Addendum: **2**

Date: **5/13/2025**

Project: **FWCS HPB Natatorium HVAC Improvements**

Comm #: **24634**

1 ENLARGED MECHANICAL PLAN
1/4" = 1'-0"

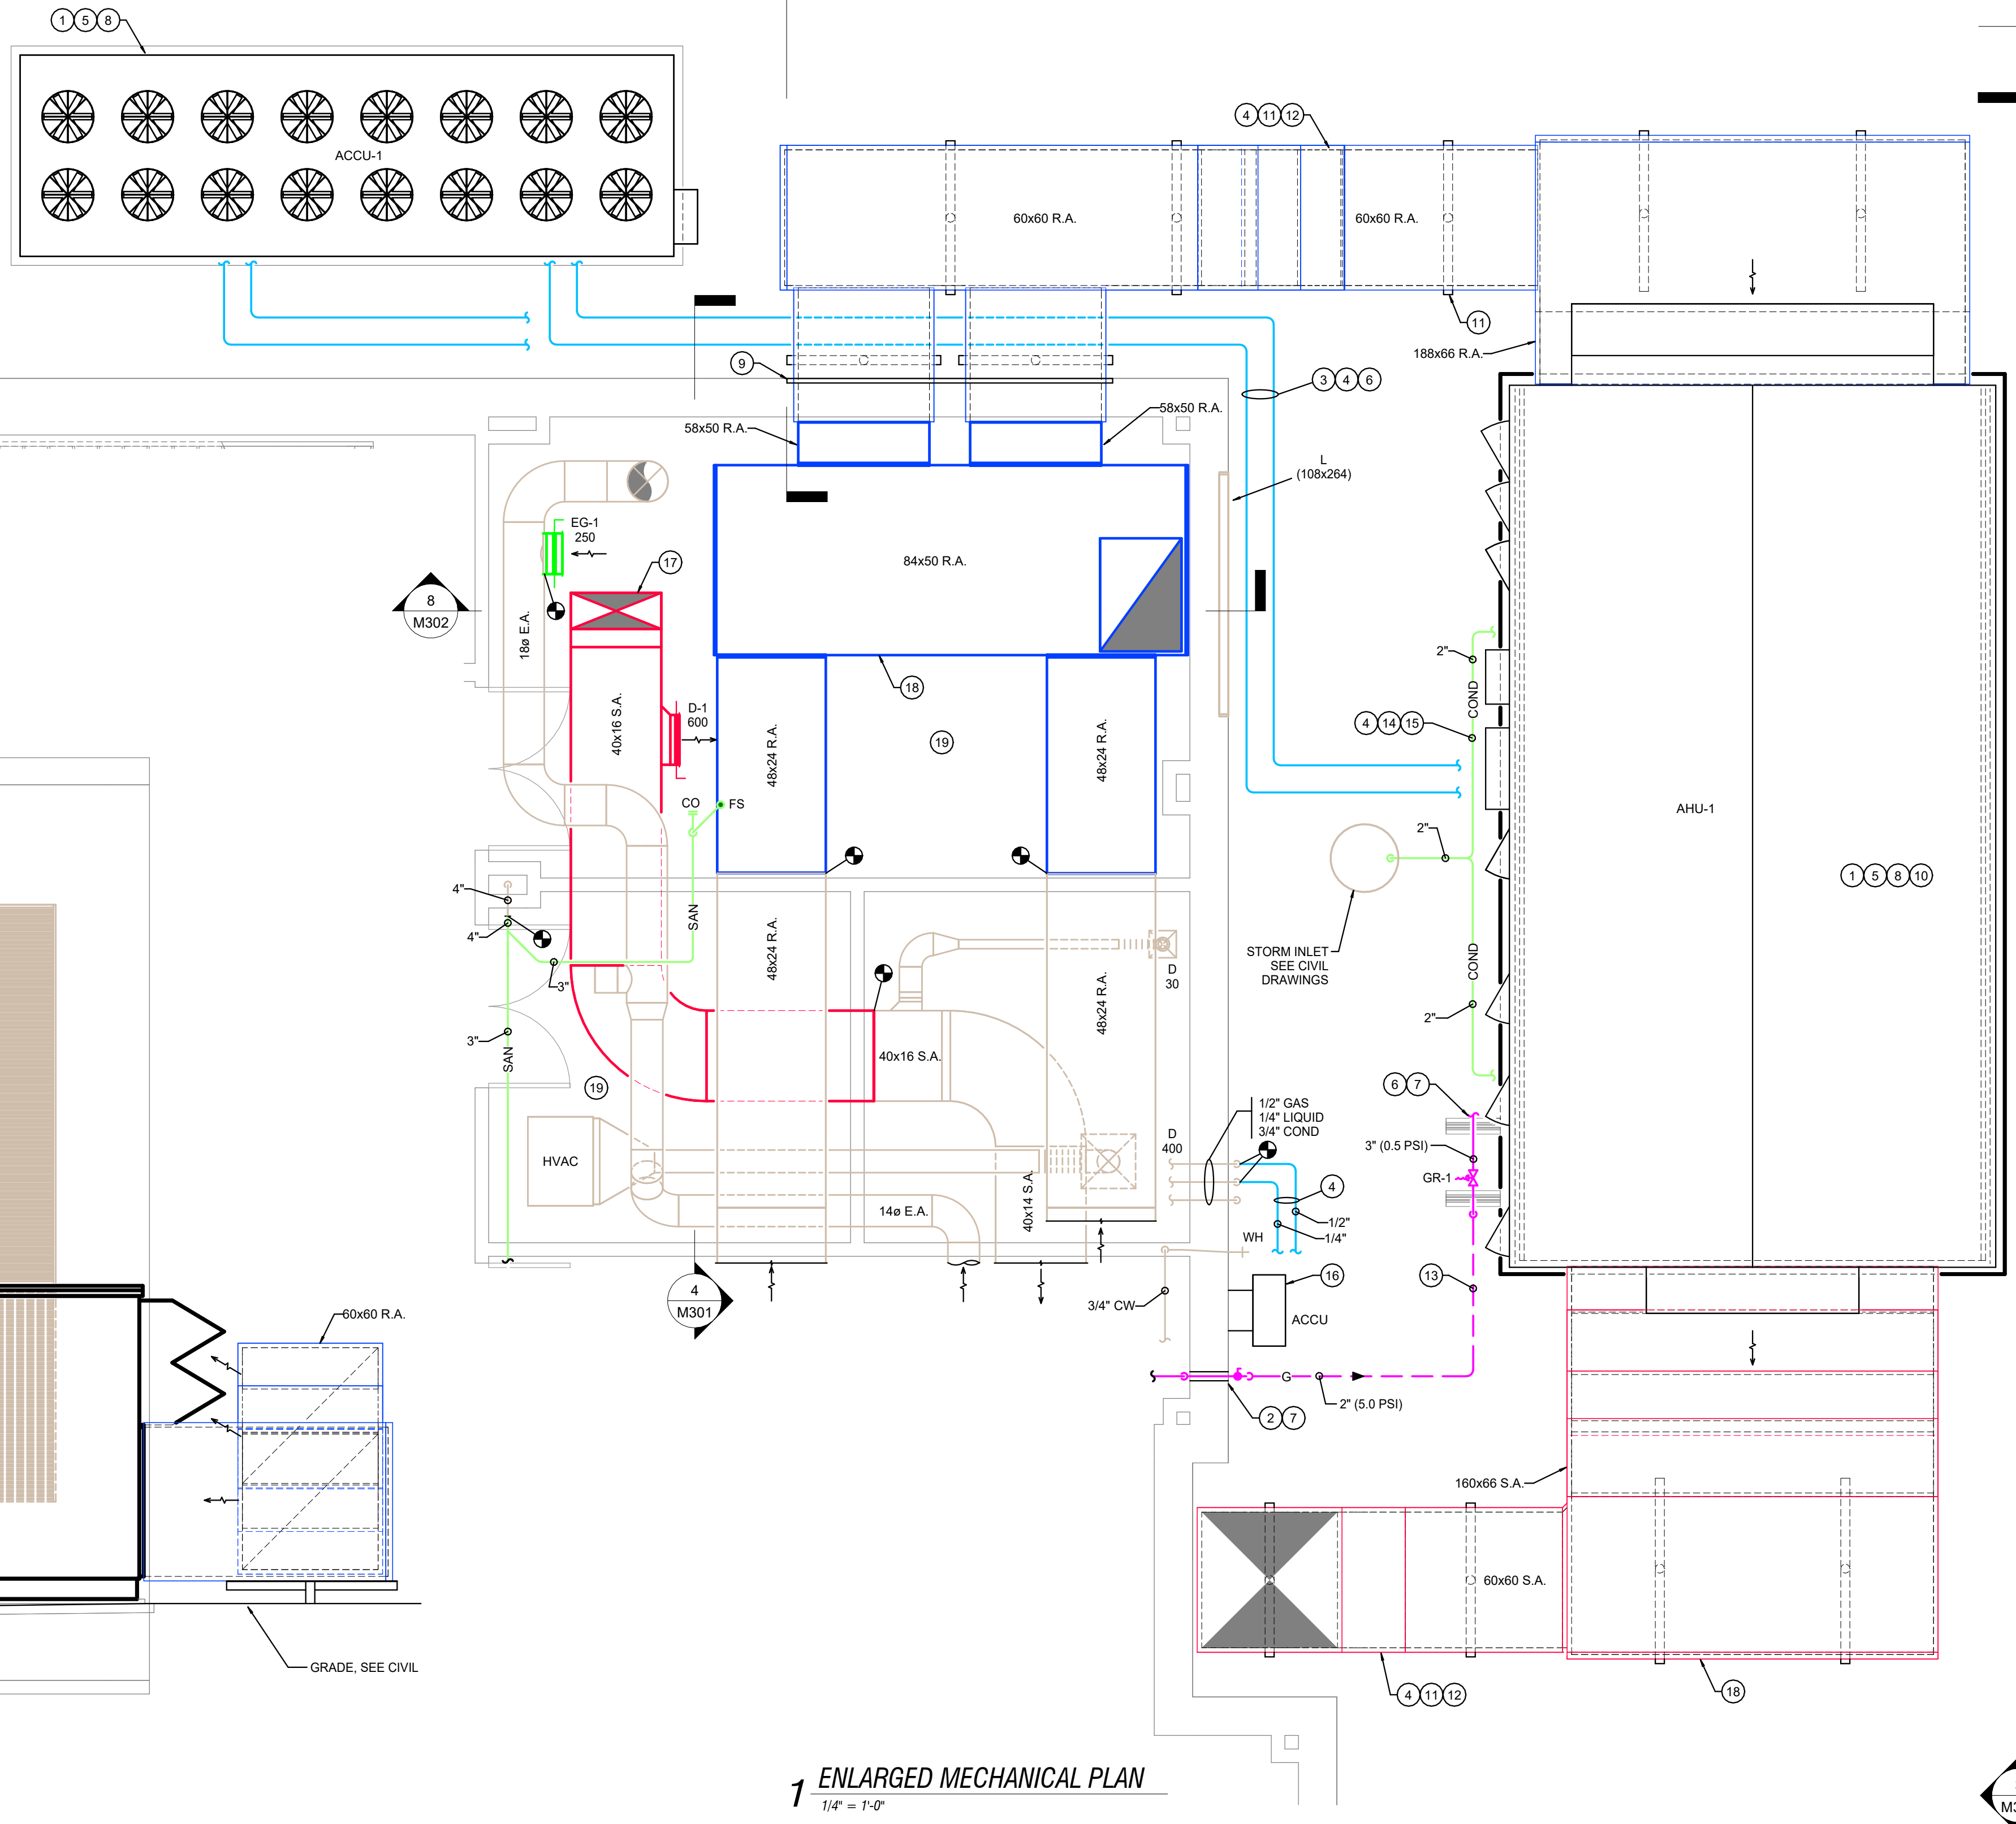
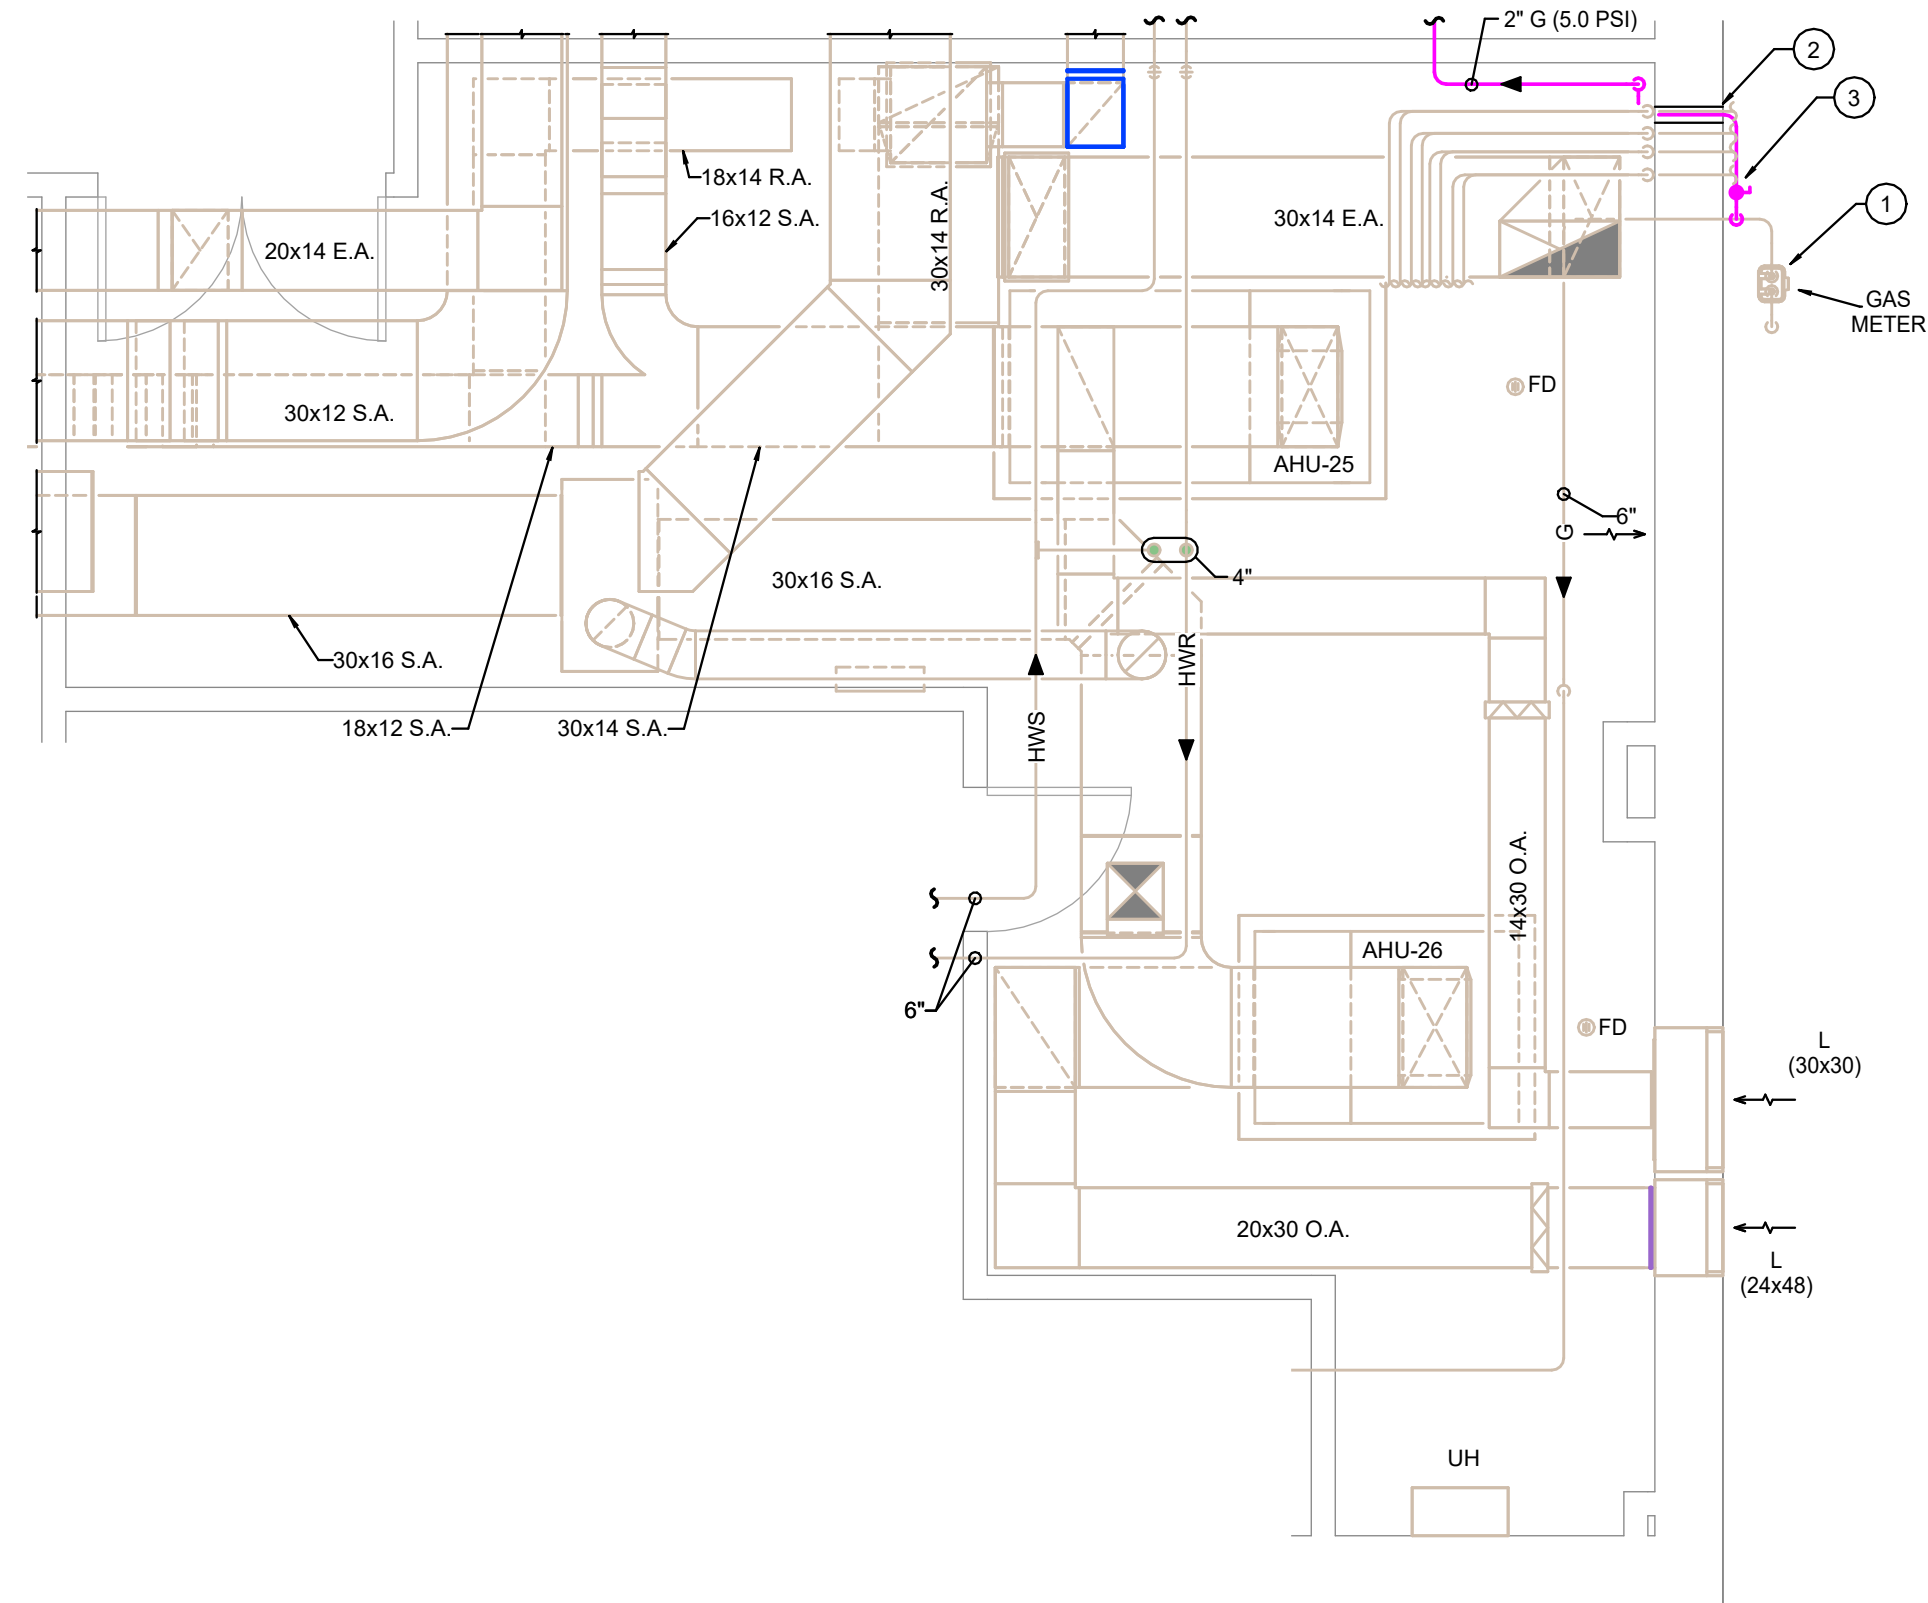
- A.** Revise louvers L-1 and L-2 to be louvers L-1, L-2, L-3, and L-4. Refer to attached drawing revision dated 5/13/2025.
